## 2508 N 50th St

MIXED-USE DEVELOPMENT  
ADMINISTRATIVE DESIGN REVIEW

DCI PROJECT NO.:  
3016479

## STREET LEVEL USE

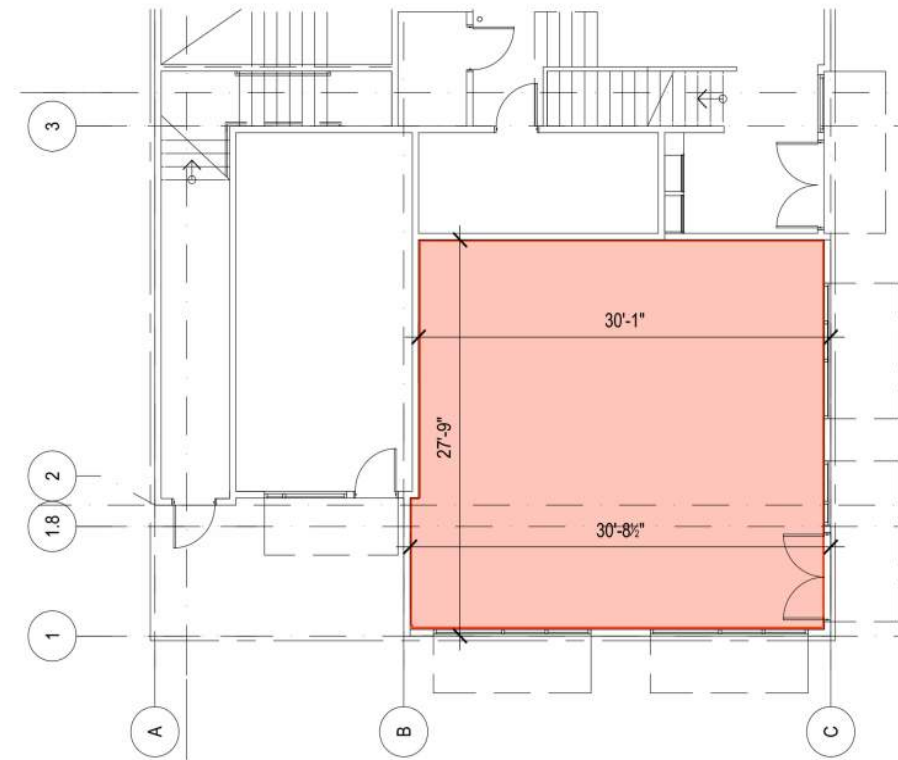
PER SMC 23.47A.005.C.1.d  
RESIDENTIAL USE MAY OCCUPY MAX 20% OF STREET LEVEL STREET FACING FACADE

CODE CITATION:	23.47.005
CODE REQUIREMENT:	<b>(C.1.d)</b> In all neighborhood commercial and C1 zones, residential uses may occupy, in the aggregate, no more than 20 percent of the street-level street-facing facade in the following circumstances or locations: E. Within an NC1 zone
PROPOSED DESIGN DEPARTURE:	N 50TH STREET: <b>36.83% PROPOSED</b> 1ST AVENUE NE: <b>24.55% PROPOSED</b>
RATIONALE:	The limited space on the corner lot reduces opportunity for residential access. The unit count and building code require two egress routes, eating away at the commercial space and growing residential ground floor width.

N 50TH STREET	1ST AVE NE	
STREET LEVEL STREET FACING	49'-4"	67'-0 1/2"	
RESIDENTIAL USE	18'-2"	16'-5 1/2"	
PERCENTAGE OF FACADE	36.83%	24.55%	<b>DEPARTURE REQUESTED</b>

## COMMERCIAL DEPTH

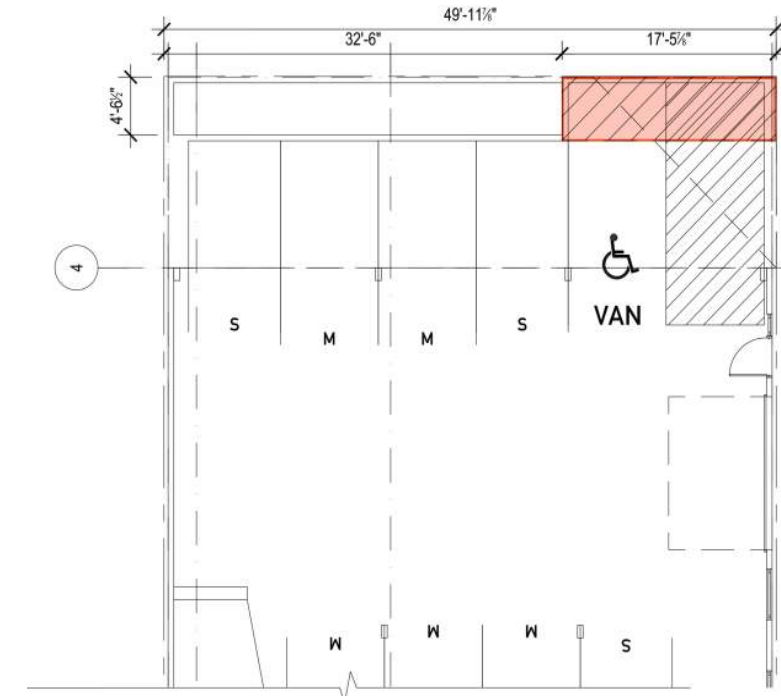
PER SMC 23.47A.008.B.3  
NON-RESIDENTIAL USES SHALL EXTEND AN AVERAGE OF 30 FEET.  
27'-9" COMMERCIAL DEPTH PROVIDED

CODE CITATION:	23.47A.008
CODE REQUIREMENT:	<b>(B.3)</b> Non-residential uses shall extend an average depth of at least 30 feet and a minimum depth of 15 feet from the street-level street-facing facade.
PROPOSED DESIGN DEPARTURE:	REQUIRED DEPTH: 30'-0" PROPOSED DEPTH: 27'-9" <b>92.5% PROPOSED</b>
RATIONALE:	Residential access and parking are located on the ground level in addition to the commercial space, restricting the amount of commercial space. The lot being located on the corner of N 50th St and 1st Ave NE requires 30 feet in depth in both directions, resulting in stricter depth guidelines. The proposed depth is just shy of 30 feet in one direction, providing close to the required amount.

## LANDSCAPING SCREENING STANDARDS

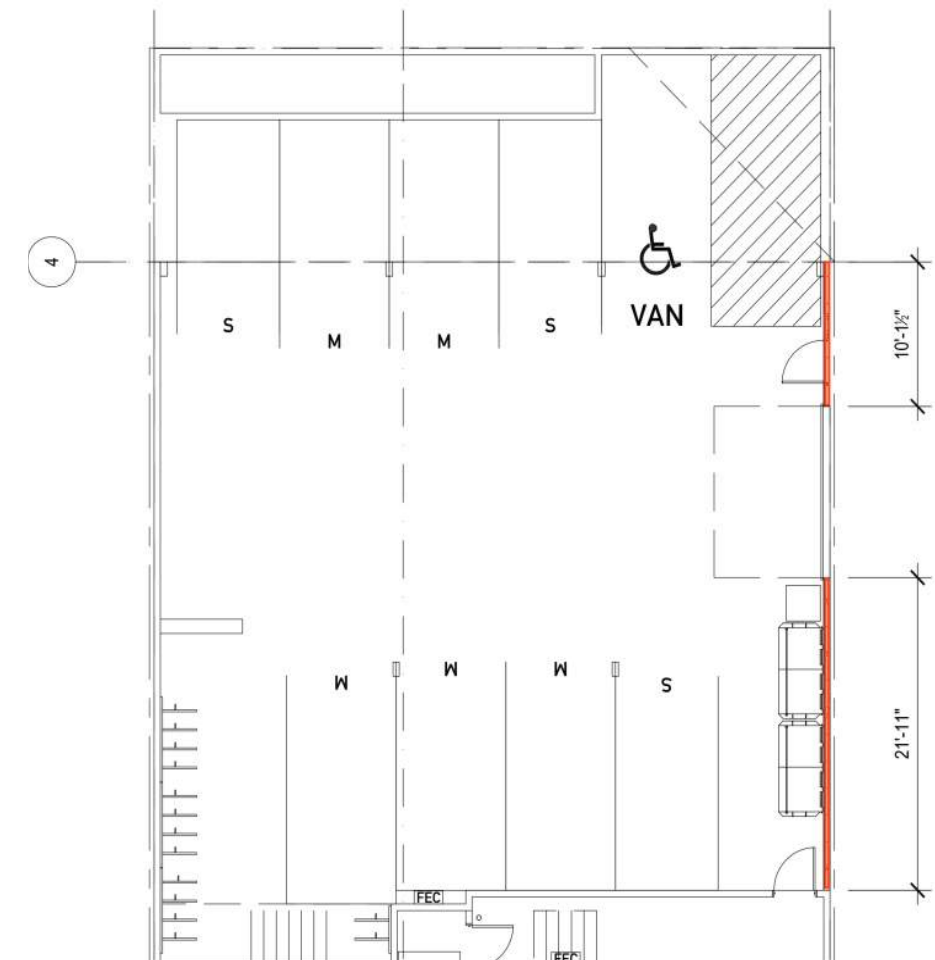
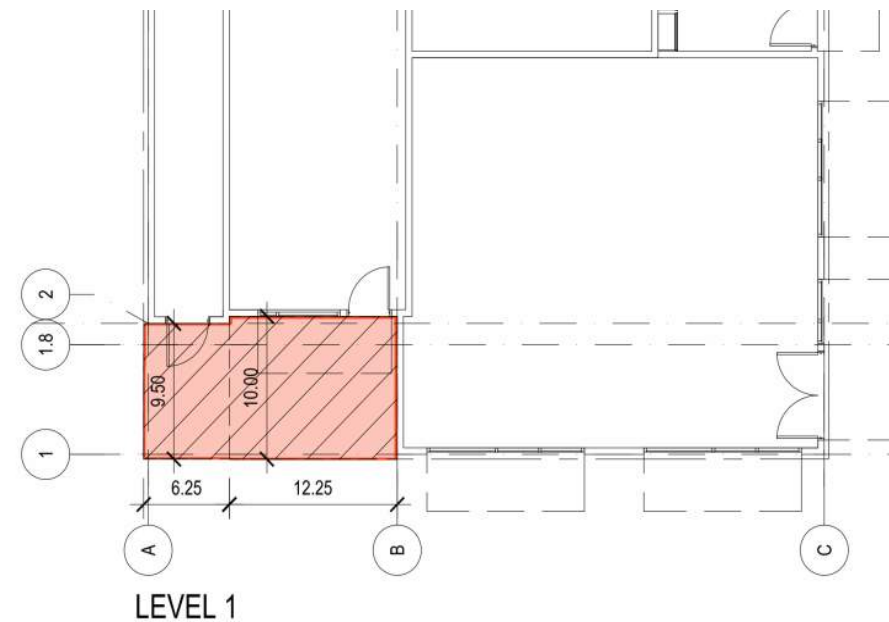
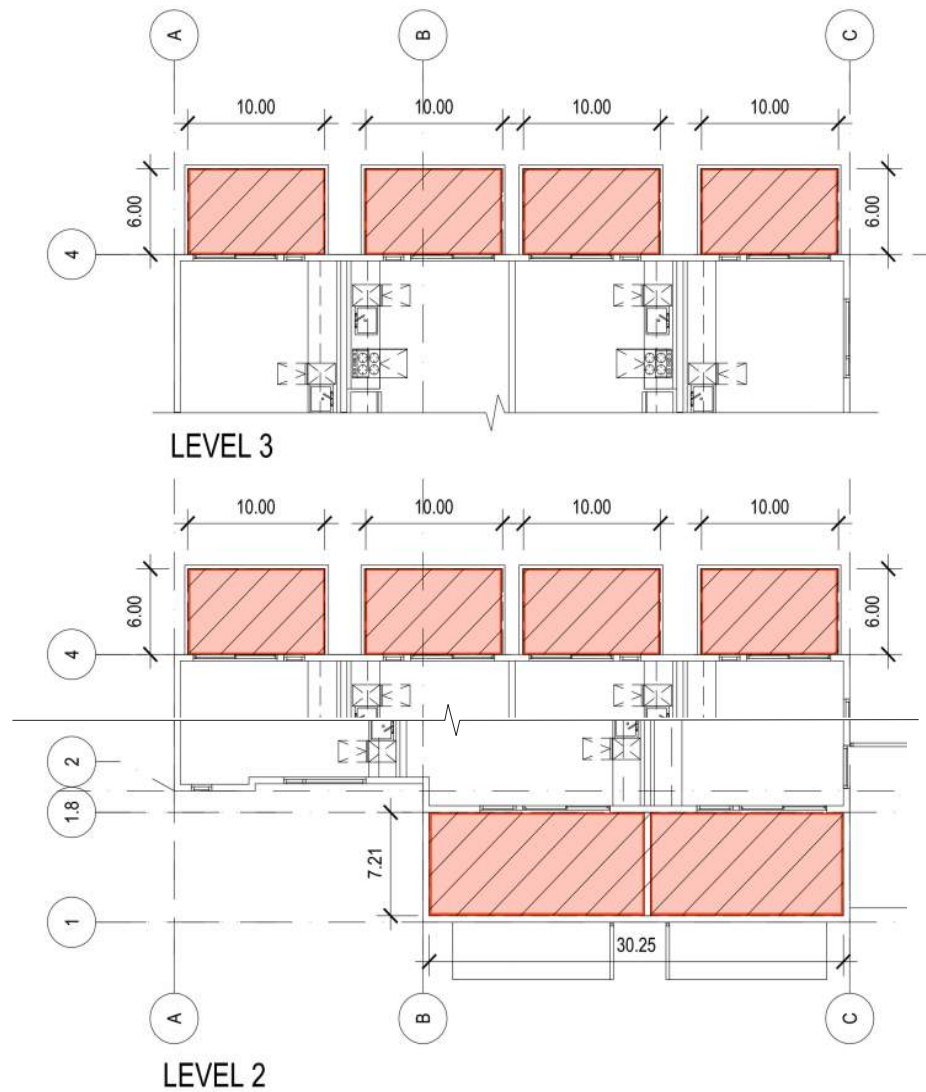
PER SMC 23.47A.016.D.1.c.2  
SURFACE PARKING ABUTTING A RESIDENTIAL ZONE MUST HAVE A 6 FT HIGH SCREEN ALONG LOT LINE AND A 5 FT DEEP LANDSCAPED AREA INSIDE SCREENING.  
LOT WIDTH = 49'-11 7/8"  
5 FT LANDSCAPED BUFFER WIDTH = 32'-6"  
REDUCTION OF 17'-5 7/8"  
**DEPARTURE REQUESTED**

CODE CITATION:	23.47A.016
CODE REQUIREMENT:	<b>(D.1.c.2)</b> Surface parking abutting or across an alley from a lot in a residential zone must have 6-foot-high screening along the abutting lot line and a 5-foot-deep landscaped area inside the screening
PROPOSED DESIGN DEPARTURE:	LOT WIDTH: 49'-11 7/8" REDUCED LANDSCAPED WIDTH: 32'-6" <b>65% PROPOSED</b>
RATIONALE:	A 6 foot tall fence, screening light and visibility of parking, is proposed to enclose the required landscape buffer. Due to the extra backing distance required for the van stall and accessible van access, additional backing distance is required. The fence being there will shield the parking from view and appear no different from the exterior of the building.
